M274 Check engine light, P052E71 Crankcase ventilation valve

Topic number	LI01.20-P-076894
Version	7
Function group	01.20 - Crankcase ventilation, cylinder head cover
Date	1/17/25
Validity	Passenger car with engine M274
Reason for change	Remedy updated

Attachments	
File	Description
Y58_2 Connection.png

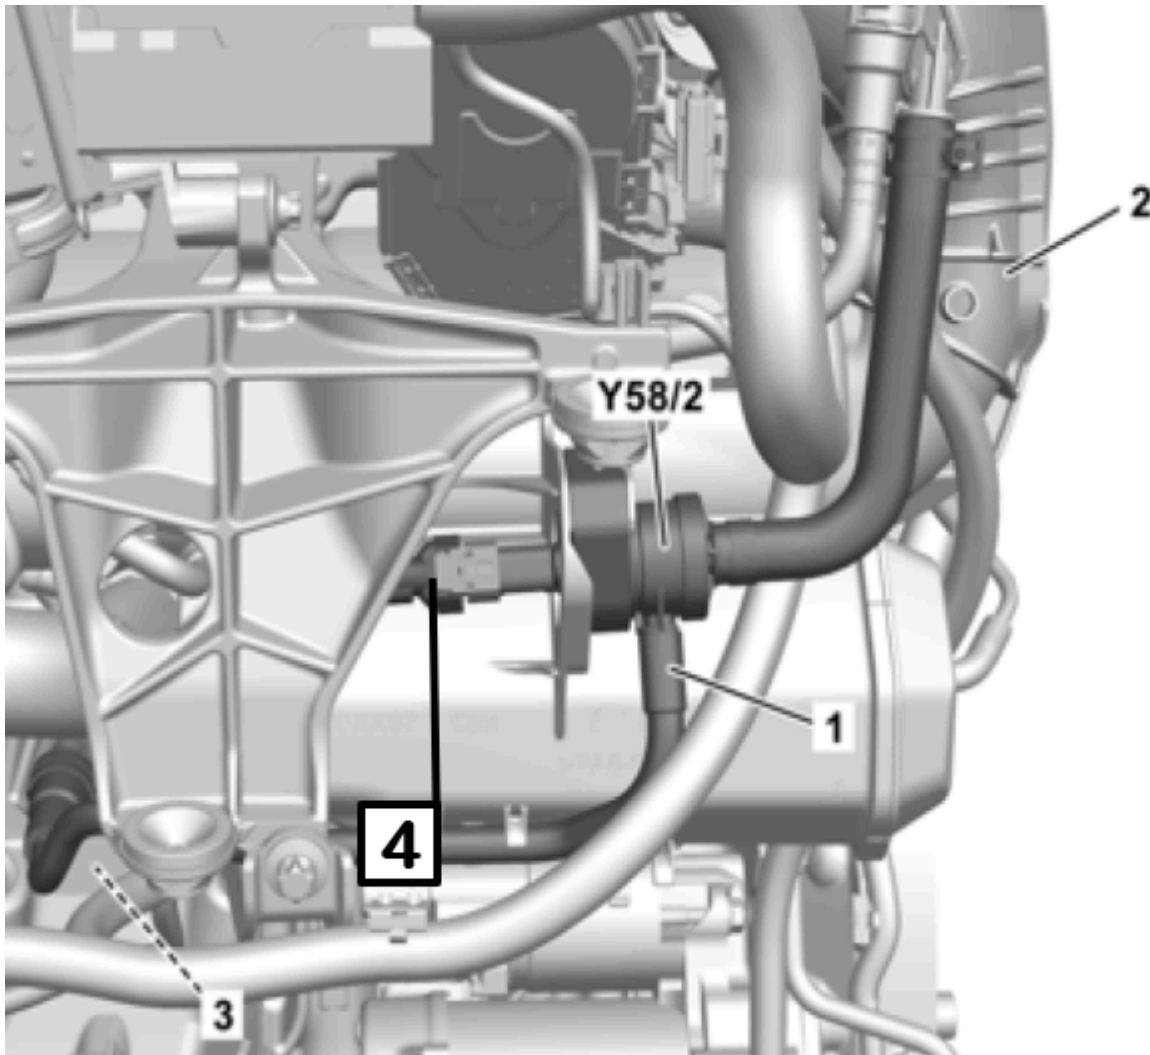
- 1- Perform software update for N3/10 Engine control unit.
- 2- Remove upper engine cover.
- 3- Unclip ME-SFI control unit (N3/10) with bracket and place to one side with connected lines (see AR07.08-P-7013M-RD).
- 4- Release and disconnect electrical connector (4) of partial-load operation crankcase ventilation valve (Y58/2).

5- Fit cap A094 545 50 03 on electrical connector (4) of engine wiring harness partial load operation crankcase ventilation valve (Y58/2) and ensure correct seating on plug of electrical connector (4).

6- Strap down electrical line (4) of partial load operation crankcase ventilation system valve (Y58/2) at wiring harness. Ensure that electrical line (4) is routed free of tension.
